Safety Alert 013

Produced with Baxi Heating UK Limited

Title: Potterton Powermax HE - Flue/Condensate Connector Erosion

Date issued: 15 November 2013

Figure 1. General Access

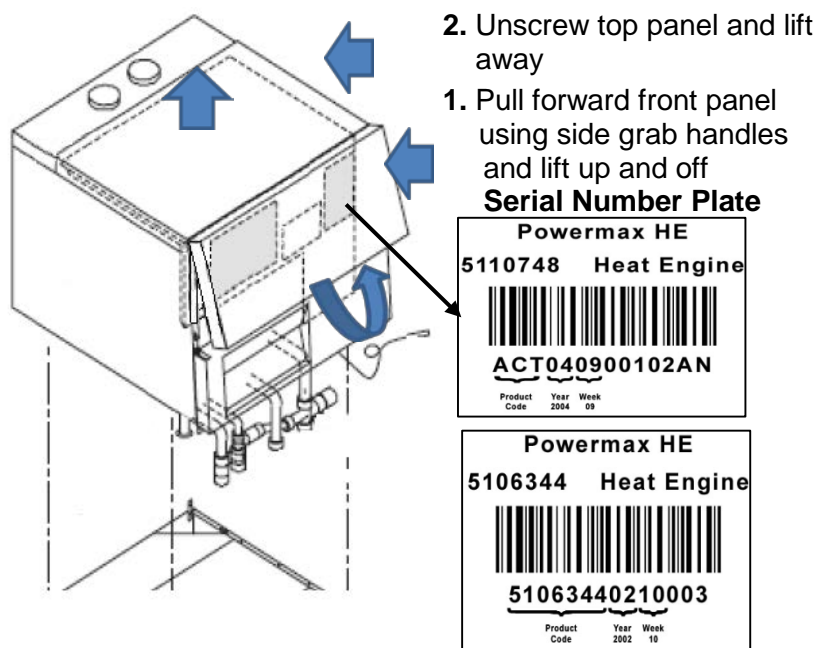
When attending a Powermax HE boiler first check to see if the serial number is in the identified range as listed in Table 1 (below). The serial number is on the data plate which is located as shown below (Fig 1) and contains two examples showing details of the year and week (YY WW) of production.

- 1) The flue/condensate connector is located behind the heat engine at the rear of the appliance. Refer to Figure 1 for access.
- 2) The top of the flue/condensate connector can be viewed from the front of the boiler with the front and top panels removed as shown in Figures 2 & 3. If the boiler has already been fitted with a new flue gas/condensate connector this will be black composite plastic (Figure 4) rather than aluminium (Figure 2).

Figure 2
Aluminium flue/condensate connector attached to the rear of the heat exchanger (Photograph shows the view from the rear of the boiler)

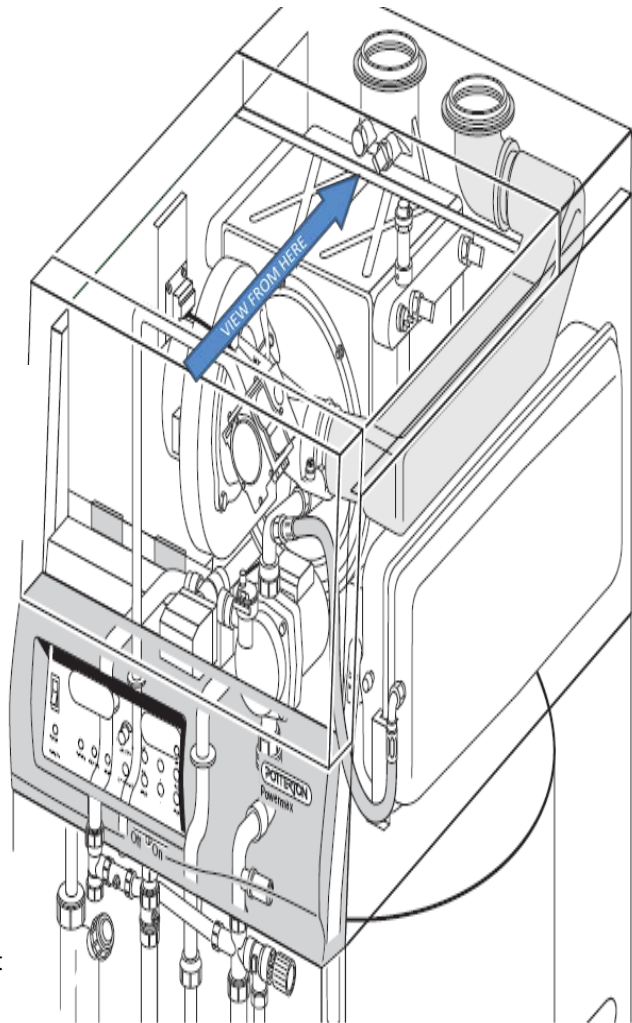
In order to increase product reliability and longevity, Baxi Heating decided to change the material from aluminium to black composite plastic. This change was made from 2005 week number 47 (which can be identified from the data badge – See Figure 1 below) as part of the Company's commitment to product improvement. Risk assessments carried out at this time determined that there was no risk to safety, although there was the possibility of pin holes occurring due to erosion of the aluminium material. Many of the existing aluminium components have already been exchanged during annual servicing and maintenance of these products.

If the boiler is found to have been manufactured within the identified range, check to see if the flue gas/condensate connector material is of aluminium. It is possible that at some stage this component has already been exchanged for the black composite plastic type. If it's of the black composite type, **no further action** is required under this Safety Alert, **however**, all appliance checks in accordance with the Gas Safety (Installation and Use) Regulations (GSIUR) 26(9)⁽²⁾ must be completed and any subsequent actions applied as appropriate.

- 3) If the component is the black composite plastic type **no further action** is required under this Safety Alert, **however** all appliance checks in accordance with GSIUR 26(9)⁽²⁾ must be completed and any subsequent actions applied as appropriate.

- 4) **If the component is aluminium** carry out a combustion analysis check by referring to the Installation & Service instructions for guidance. If the customer does not have the instruction booklet to hand, it can be found at: <http://www.partsarena.com/baxi>. A combustion test point is provided on the flue/condensate connector. Typical values to be expected are: **At maximum input:** CO < 80ppm & CO₂ < 9.5%. **At minimum input:** CO < 20ppm & CO₂ < 8.9%

Baxi Heating Ltd., **recommends** that all the aluminium components of this type are exchanged irrespective of their current condition.
